Date: May 28, 2024
Attention: Kimberly Thompson, Natural Resource Specialist, FrontCounter BC
Re: Crown Land Tenure Application (Tracking Number 100439391)
 Land / Foreshore Use Application: Shoreline Erosion Mitigation ("Green Shoring")
 Information Request IR-001

10 **INFORMATION REQUEST RESPONSES**

PROJECT TITLE:
BEACH EROSION PROJECT
2022.68 QUARRY DRIVE

FIGURE 9:
15 YEAR CROSS-SECTION

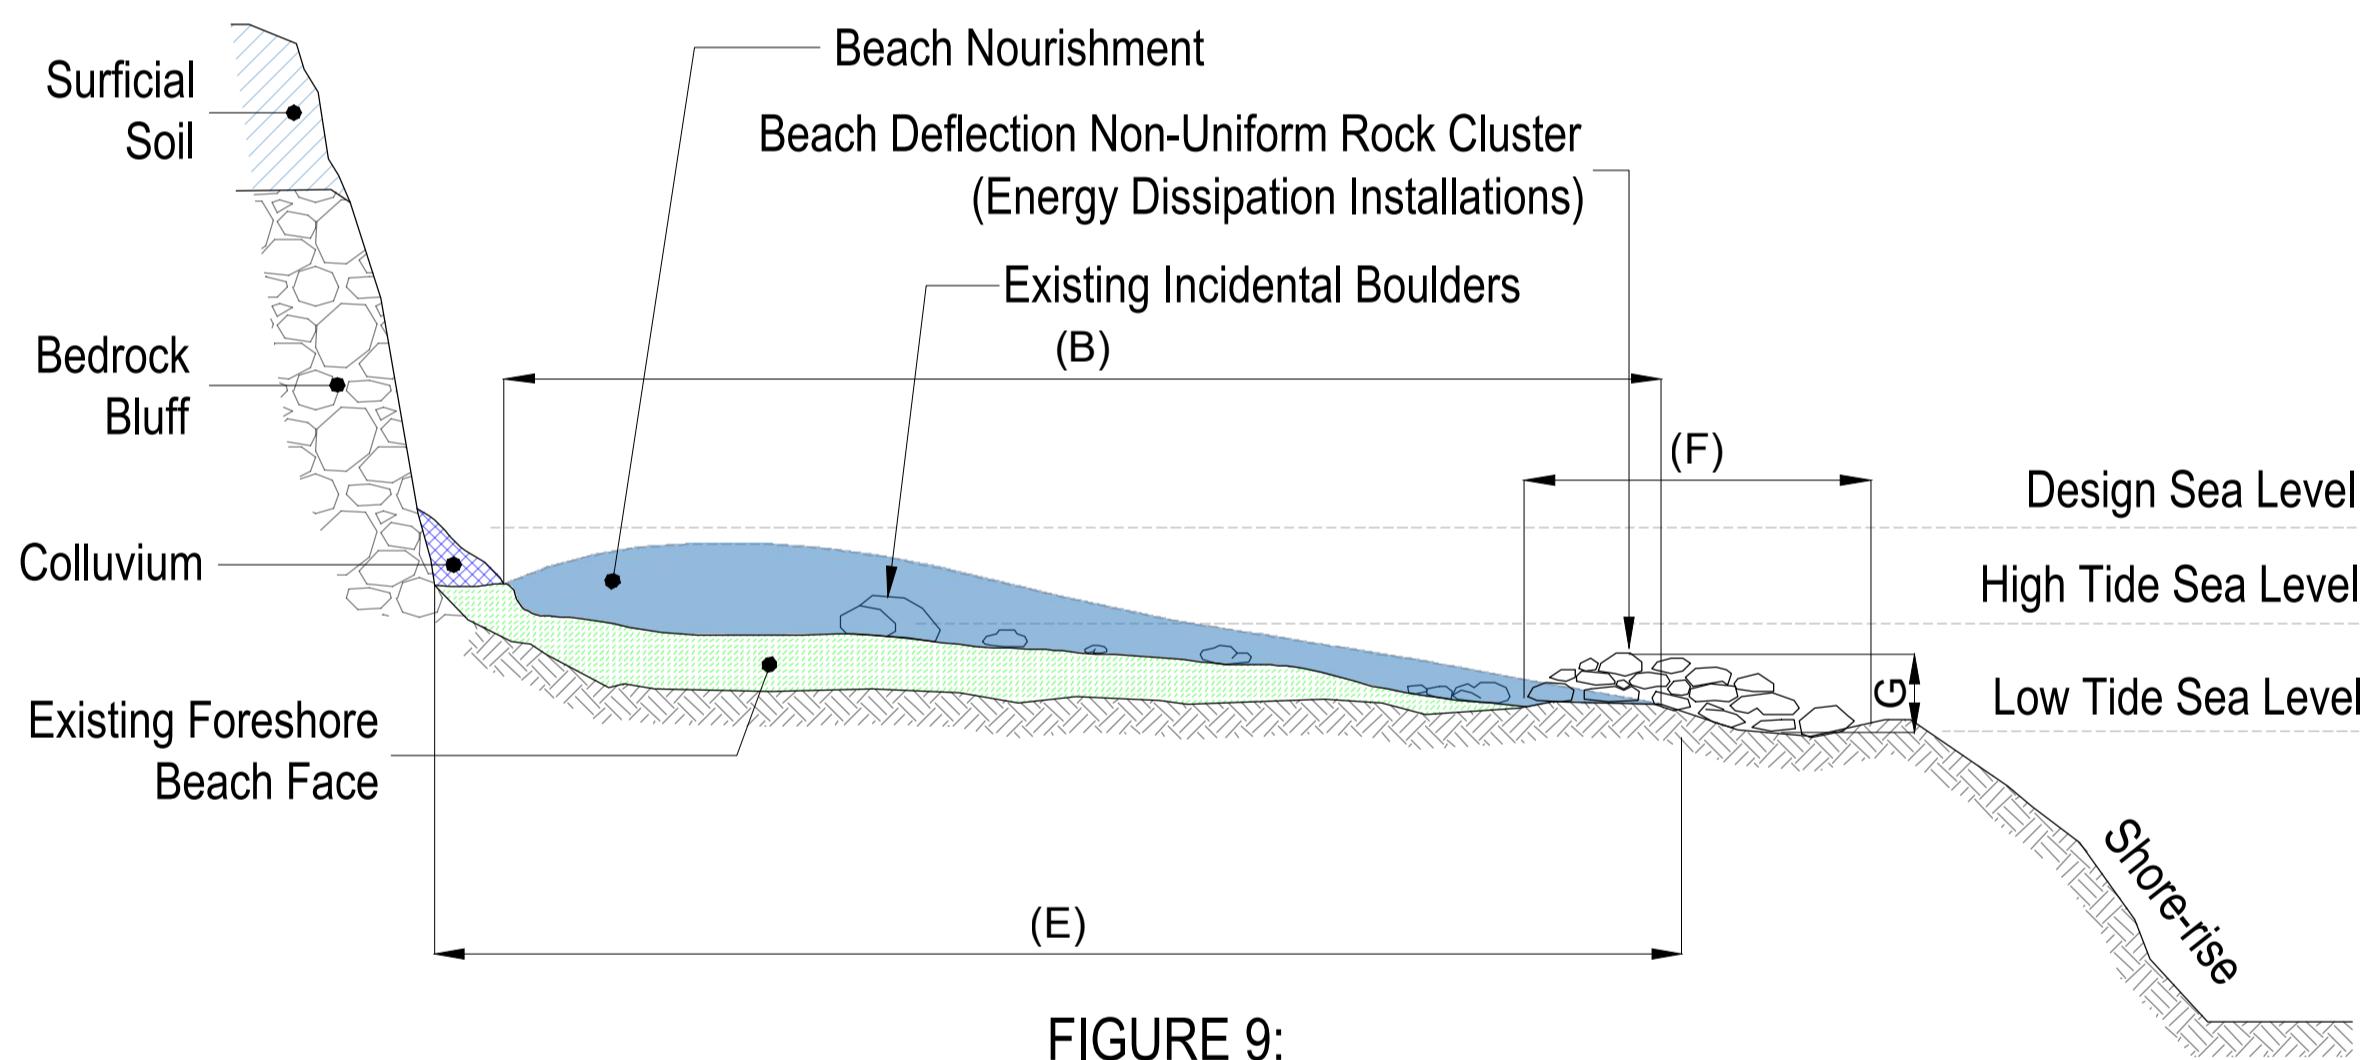
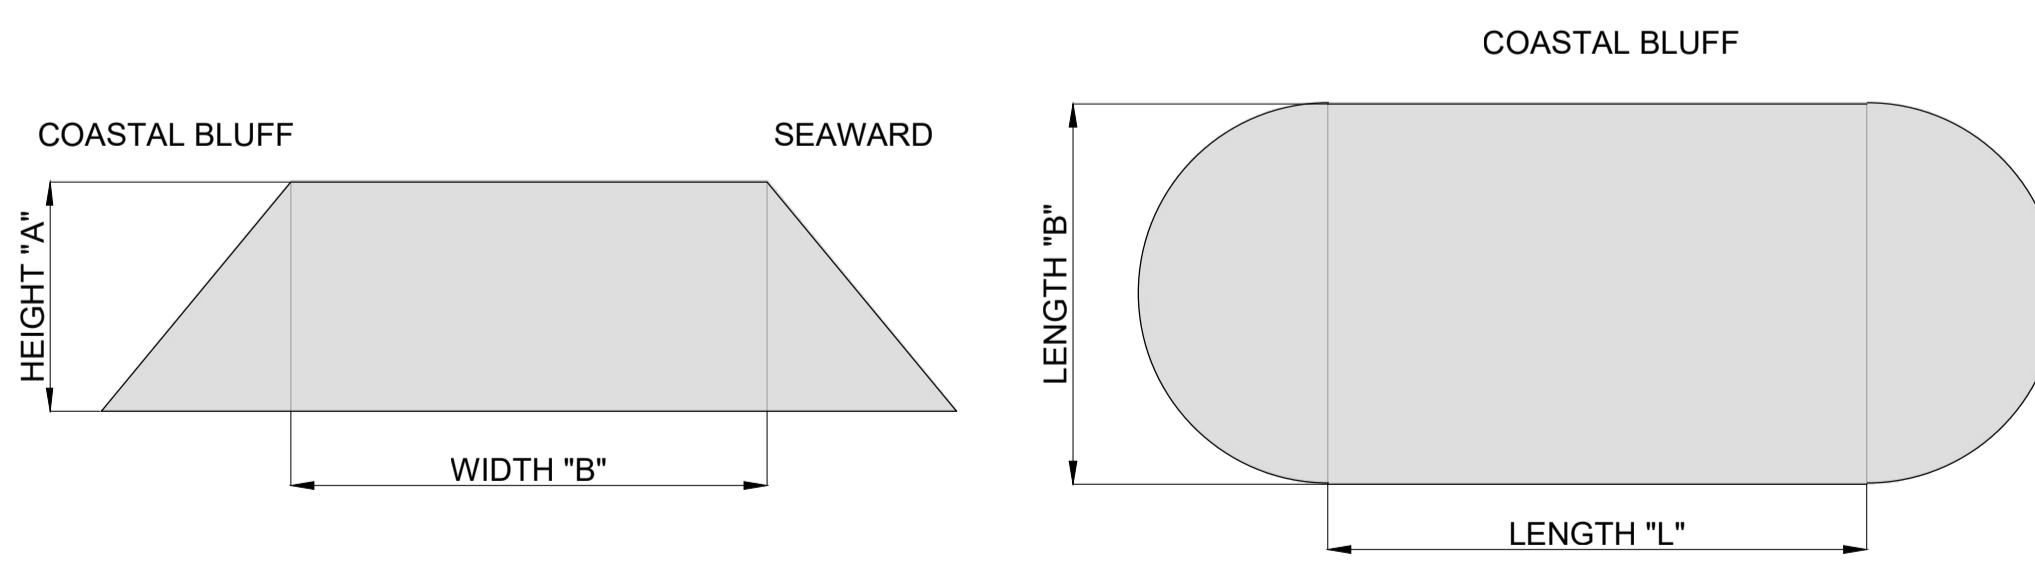
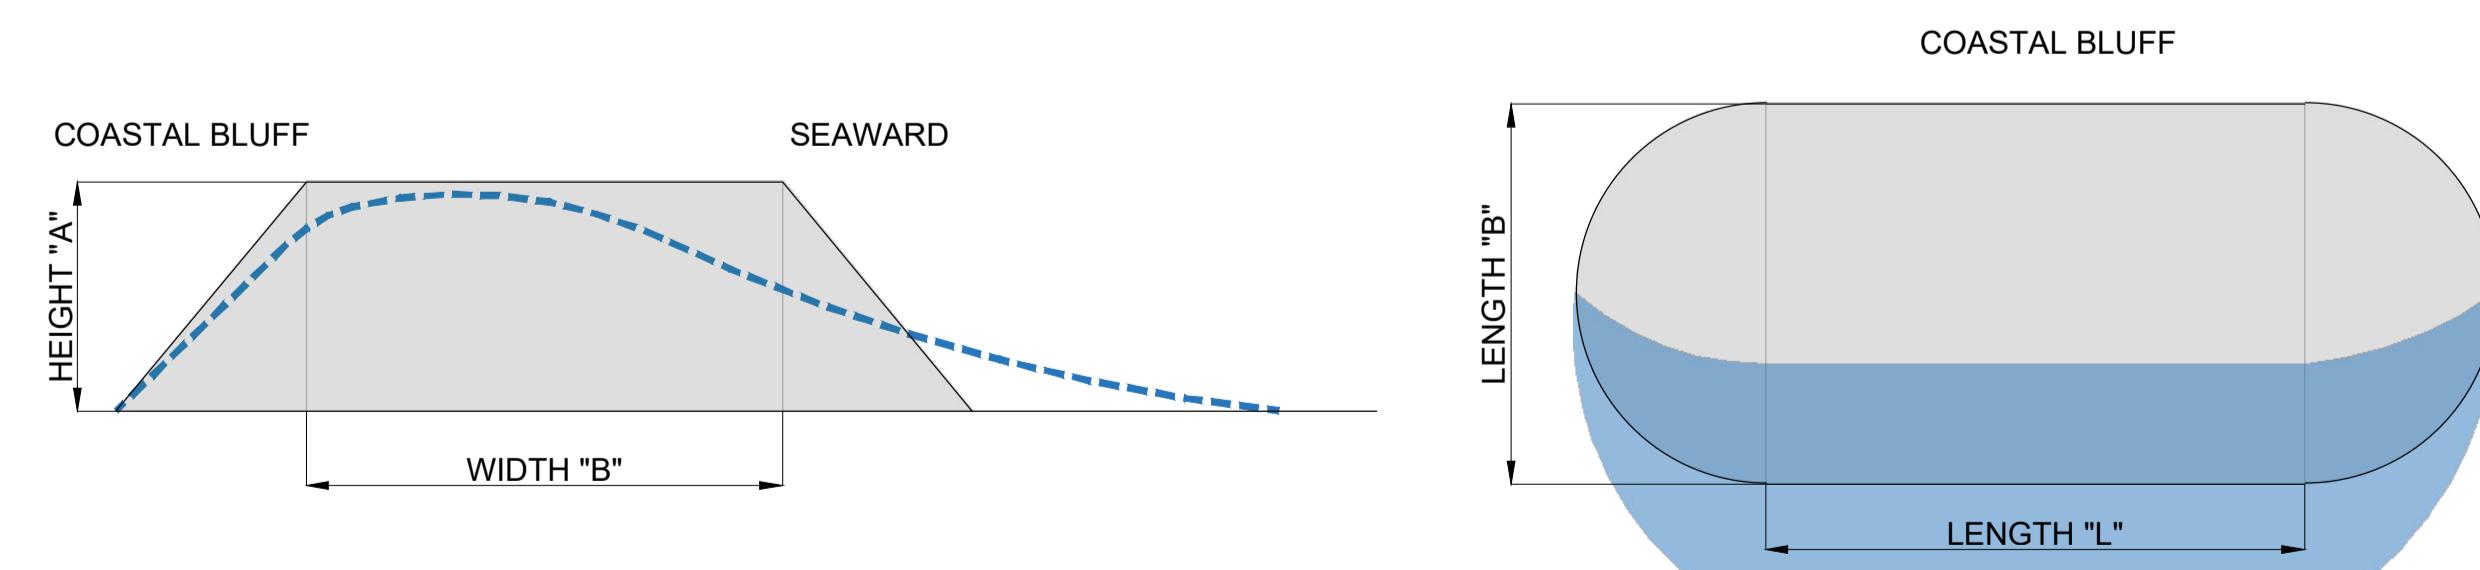
29 04. *Section 3.2 of TRE's "Assessment of Marine Shoreline Characteristics" report recommends sparse
 30 placement of boulders in the indicated areas to deflect waves. However, the side view plan in the
 31 drawing package shows non-uniform rock clusters. Please update the application package to
 32 provide more information about the boulders or rock clusters such as the size range of the rocks,
 33 approximate size of each cluster, approximate number of clusters and approximate spacing
 34 between clusters.*

- 43 • Response IR-001.04.2 (GEO, TRE): Cluster Specification
- 44 i. 0.5 – 1.2m boulders, sandstone or low sulphide granite, rounded to sub-rounded
45 (no blast rock)
- 46 ii. Amoebic clusters of 10 – 15, generally with 20% density within the areas
47 designated on the plans.
- 48 iii. Spaced 0.5 – 1.0m
- 49 iv. -Placed on the largest side to minimize topple/movement
- 50 • Response IR-001.04.3 (ENG): Drawings have been updated to include further "wave
51 energy dissipation installations" terminology.
